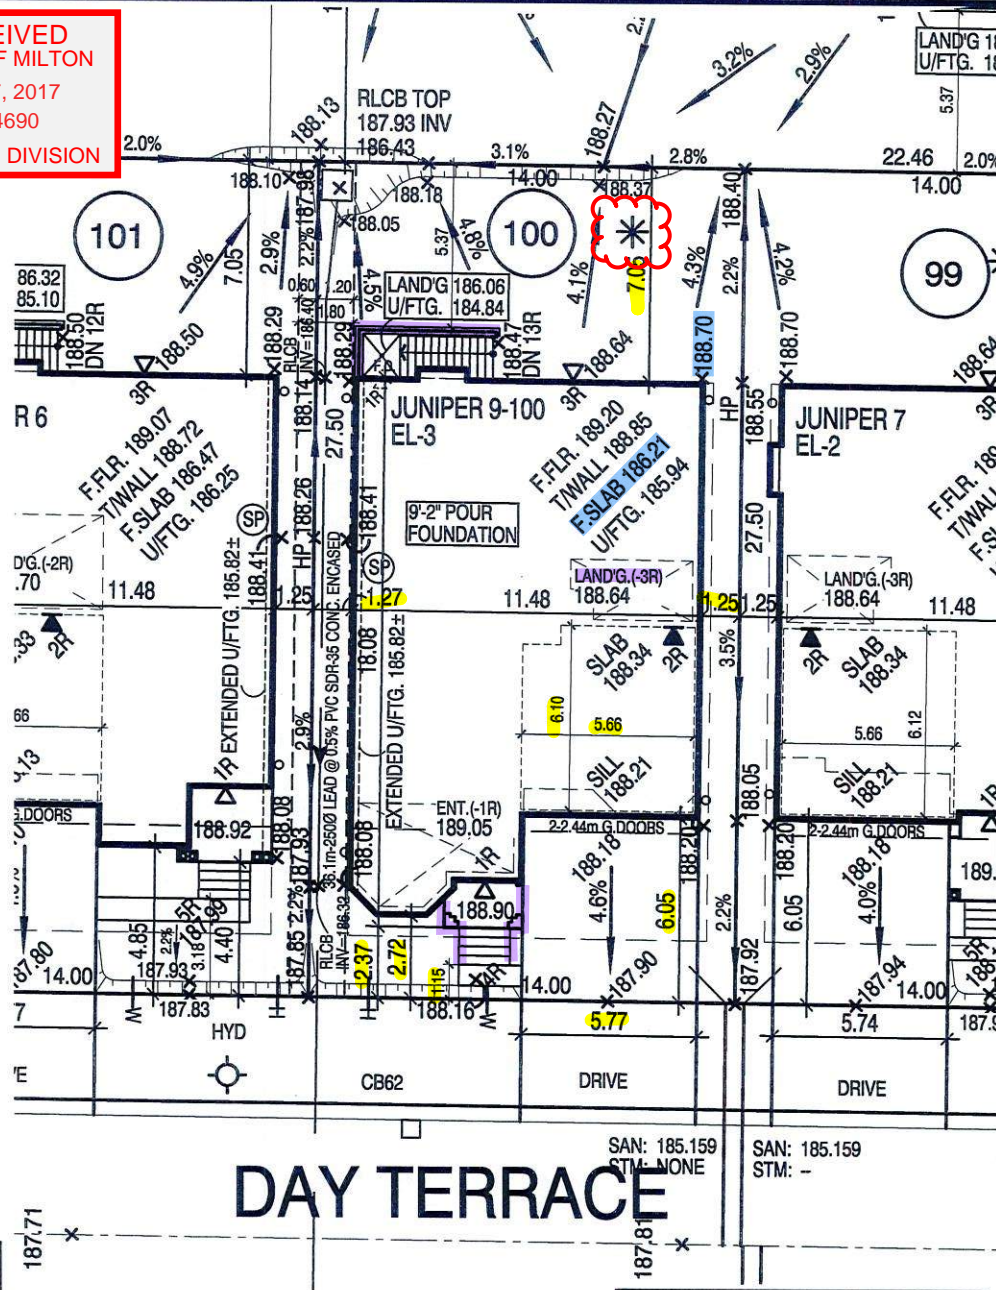
45 Min FRR

45 Min FRR w/NC Cladding

Guard/Handrail as per 9.8.

2.49 m Backfill height as per 9.15.

Siting to be read in conjunction with reviewed main model drawings

FOUNDATION BACKFILL HEIGHT

See reviewed permit drawings for engineered foundation detail for maximum 2.5 m backfill height (requires 10" thick foundation wall)
